Access Compliance Report Public Rights-of-Way (Pedestrian Signals)

Intersection ID: N/A	Main Street:	Cross Street: N/A	Location: N/A
ADA ID: 8CF5614EB4B5	Signal Type: Two Push Buttons-Non APS	Overall Compliance: No	Severity Score: BTN 1:N/A BTN 2: N/A No BTN: N/A
Codes/Mitigation Info/Possible Solution		Field Measurements/Component Compliance

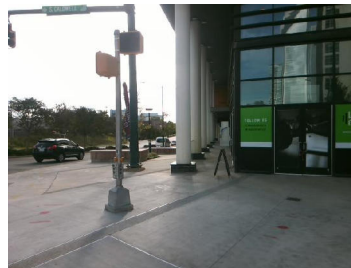
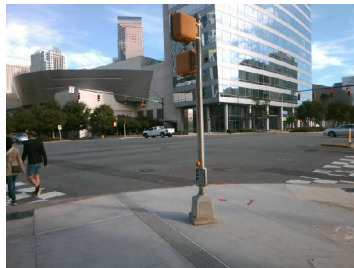
PROW/ADA: TMUTCD 4e.08, R406.2

Yes	B 1 Clear Xing Direction?	ClearlyMarked	Yes	B 2 Clear Xing Direction?	ClearlyMarked
	B 1 Crossing Direction	To NW		B 2 Crossing Direction	To NE
Yes	B 1 DistanceTo XWalk (in)	0.0	Yes	B 2 DistanceTo XWalk (in)	0.0
No	B 1 DistanceTo Curb (in)	130.0	No	B 2 DistanceTo Curb (in)	220.0
Yes	B 1 Diameter (in)	2.0	Yes	B 2 Diameter (in)	2.0

Possible Solutions: Replace Signal Push Button With APS Button on New Post. Remove & Relocate Sign.
